Service Bulletin 599

Subject: Starter Solenoid and Rear Grab Handle Torque Check				
Bulletin Number	Models Affected	VIN Range		Markets Affected
599	Tiger 900 Tiger 900 GT Tiger 900 GT Pro Tiger 900 Rally Tiger 900 Rally Pro Tiger 900 GT- LRH (Low Ride Height) Tiger 900 Bond Edition Tiger 850 Sport	From AZ6646	To BF1279	All Markets except Brazil and India

1. Cover

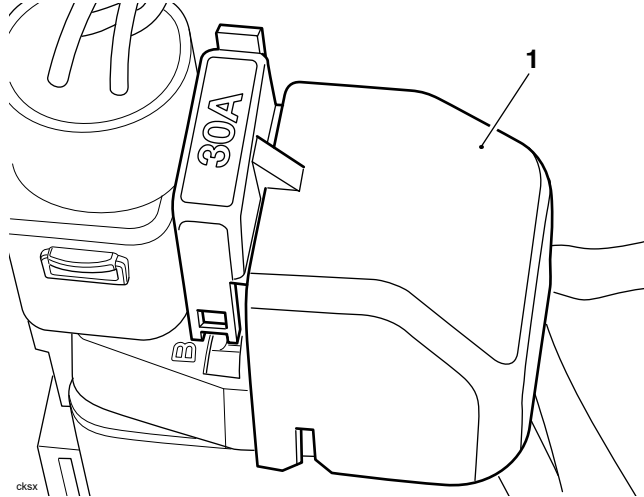
1. Remove the following components as described in the Service Manual:
 - Rider's seat
 - Battery
2. Detach the starter motor solenoid from the base of the rear mudguard.
3. Remove the cover from the starter motor solenoid.

1. Solenoid cable fixings

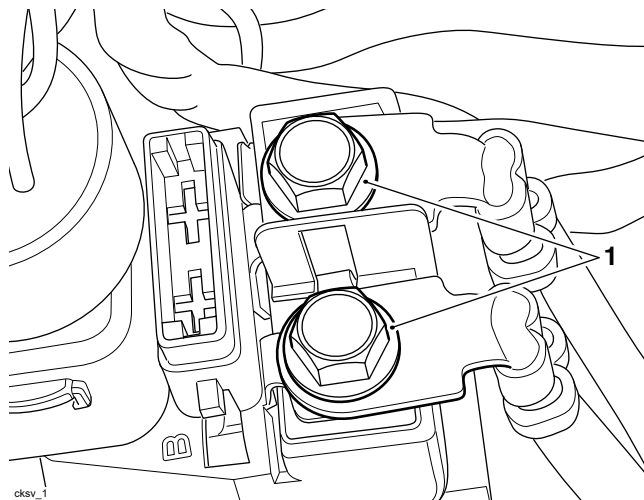
4. Tighten the two cable fixings to 5 Nm.

- 1. **Rear grab handle**
- 2. **Rear fixings**
- 2. Fit the following components as described in the Service Manual:
 - Battery
 - Rider's seat

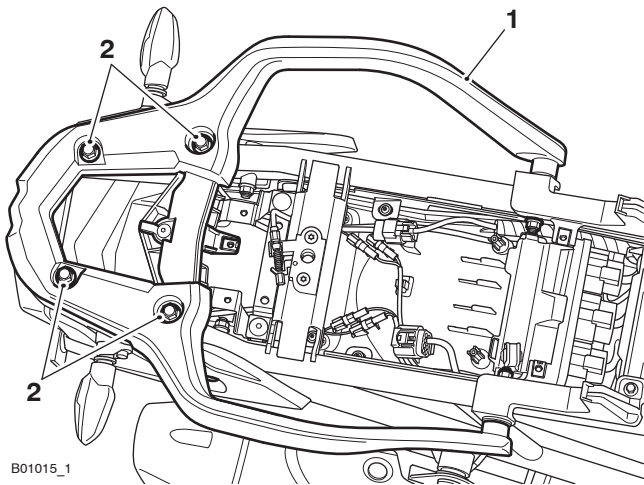
- 1. Tighten the four rear fixings that attach the rear grab handle to the rear subframe to 25 Nm.
